SUBJECT: EDWIN I. HATCH NUCLEAR PLANT, UNITS 1 AND 2 – REQUEST FOR
ADDITIONAL INFORMATION (TAC NOS. MF6063 AND MF6064)

REQUEST FOR ADDITIONAL INFORMATION

REGARDING CHANGES TO TECHNICAL SPECIFICATION SECTIONS 1.0, 3.4.9, AND 5.0

EDWIN I. HATCH NUCLEAR PLANT, UNITS 1 AND 2

Figure 1: Results of NRC's Independent Calculation of Curve B for Hatch Unit 1 at 38

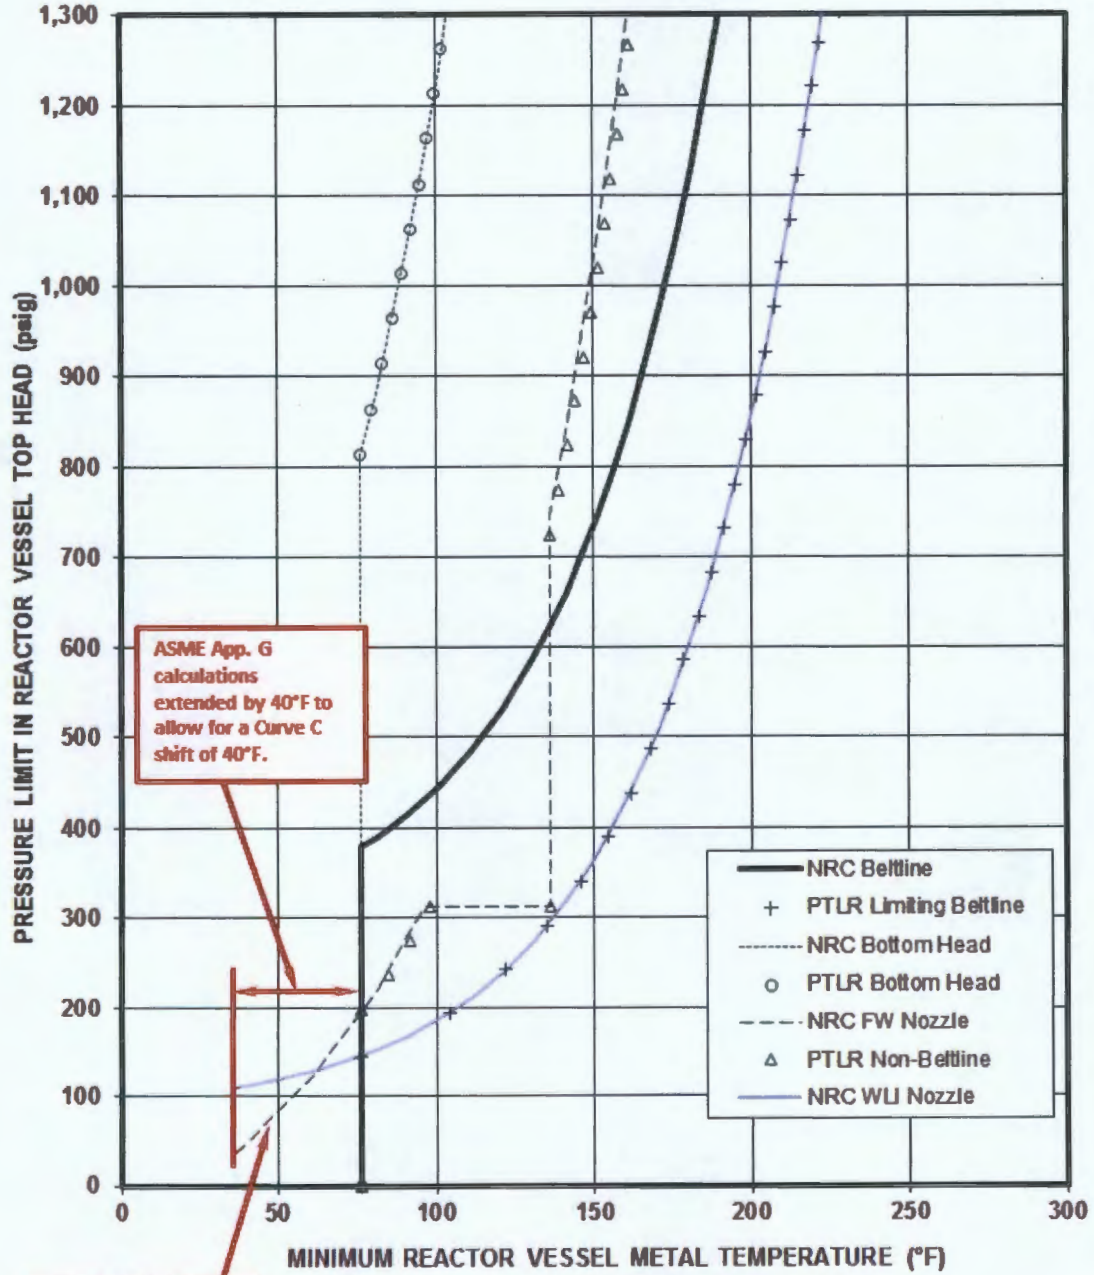
Page 15 of Calculation No. 1001527.304, Rev. 2, as provided in the November 12, 2015, supplement, states that the feedwater nozzle thermal stress intensity factor (K_{IT}) was scaled based on the available temperature differential. The NRC staff approximated this scaling in their independent assessment based on the information available in the documents supplied by the licensee. The NRC staff recognizes that there may be some differences caused by this approximation. However, based on the comparison of results in Figure 1, the staff's

approximation yields very close agreement to the licensee's Curve B for temperatures greater than 76 degrees Fahrenheit (F), so any differences caused by the staff's approximation appear to be insignificant.

Figure 2: Results of NRC's Independent Calculation of Curve C for Hatch Unit 1 at 38

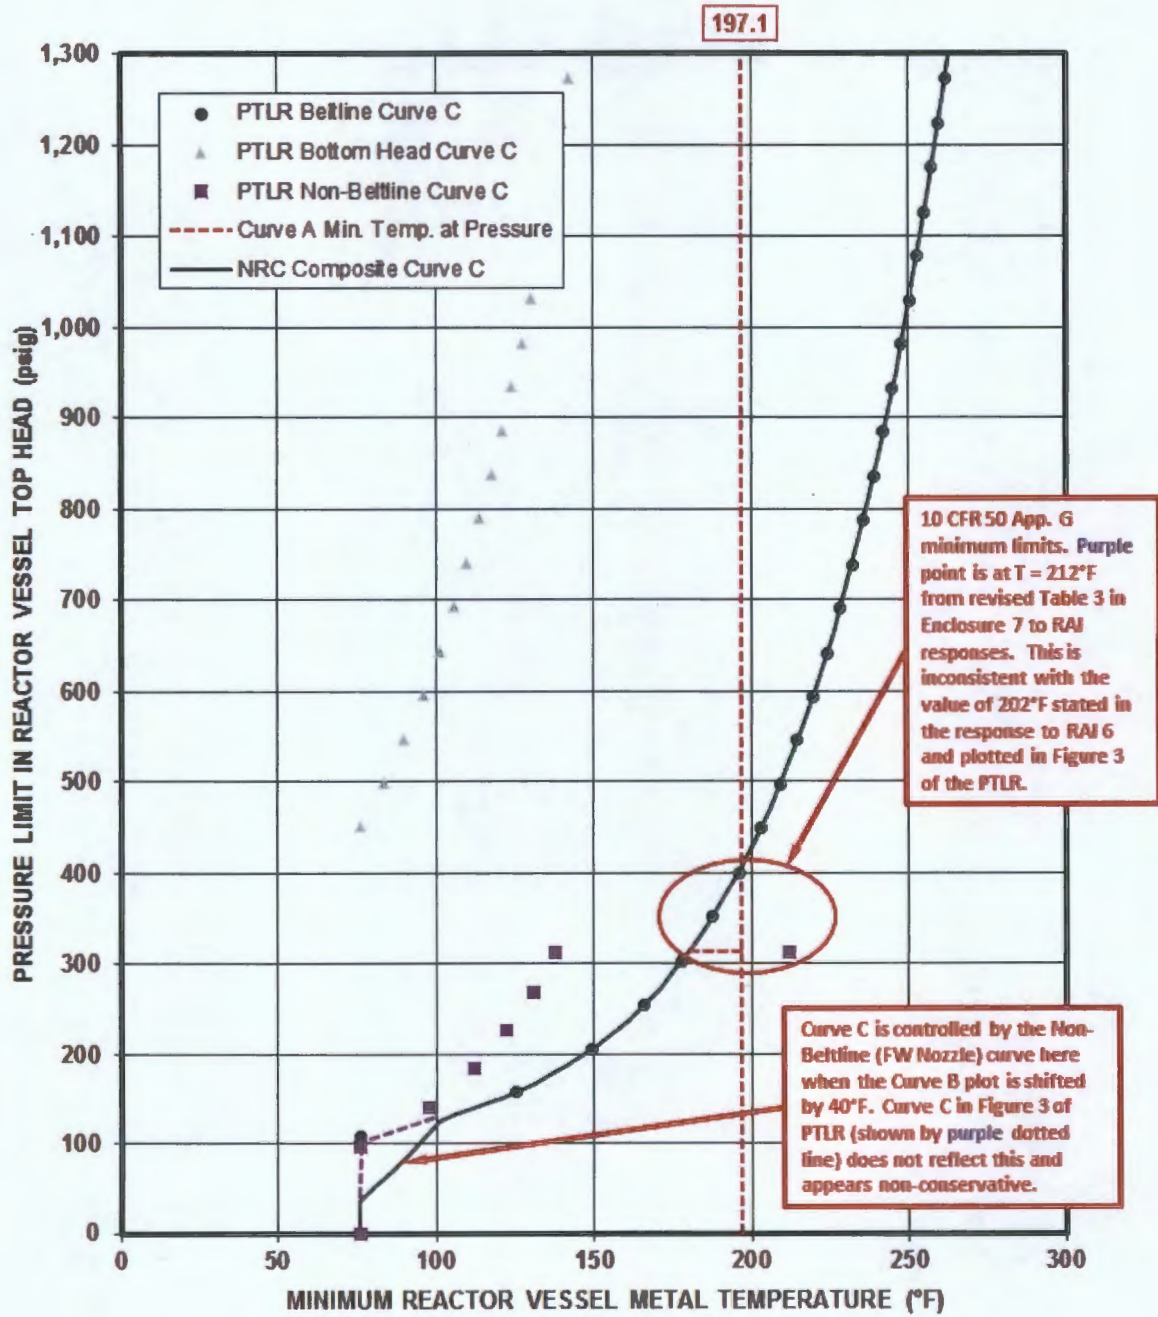
The NRC staff was able to successfully reproduce all of the pressure-temperature (P-T) curves for HNP, Unit 2, for 50.1 effective full power years (EFPY). The NRC staff was able to successfully reproduce all of the P-T curves for HNP, Unit 1, for 38 EFPY except for one portion of Curve C. Figures 1 and 2 provide the results of the NRC's independent evaluation for HNP, Unit 1, at 38 EFPY for Curves B and C, respectively. As noted by the two text box annotations in Figure 1 and the lower text box in Figure 2 that begins with, "Curve C is controlled...", the NRC's evaluation indicates that the licensee's Curve C may not meet ASME Boiler and Pressure Vessel (B&PV) Code, Section XI, Appendix G (2004 Edition, per the PTLR Topical Report BWROG-TP-11-022-A, Revision 1), minimum temperature limits and therefore may be non-conservative.

Please clarify whether the lower portions of Curve C for Hatch 1 for HNP, Unit 1, 38 and 49.3 EFPY adequately bound the non-beltline region.

In the response to RAI 6 of the November 12, 2015, supplement, the licensee states that the values in Table 3 of the HNP, Unit 1, PTLR should list a temperature of 202 degrees F for pressures greater than 312.6 pounds per square inch gauge (psig). A revised Table 3 was provided in Enclosure 7 to the licensee's RAI responses. However, revised Table 3 in that enclosure lists a revised temperature of 212 degrees F for pressures greater than 312.6 psig. This value does not match the licensee's response, nor does it match the value plotted in Figure 3 of the HNP, Unit 1, PTLR. Refer to the text box that begins with, "10 CFR 50 App. G minimum limits," in Figure 2 above. Please clarify this discrepancy.
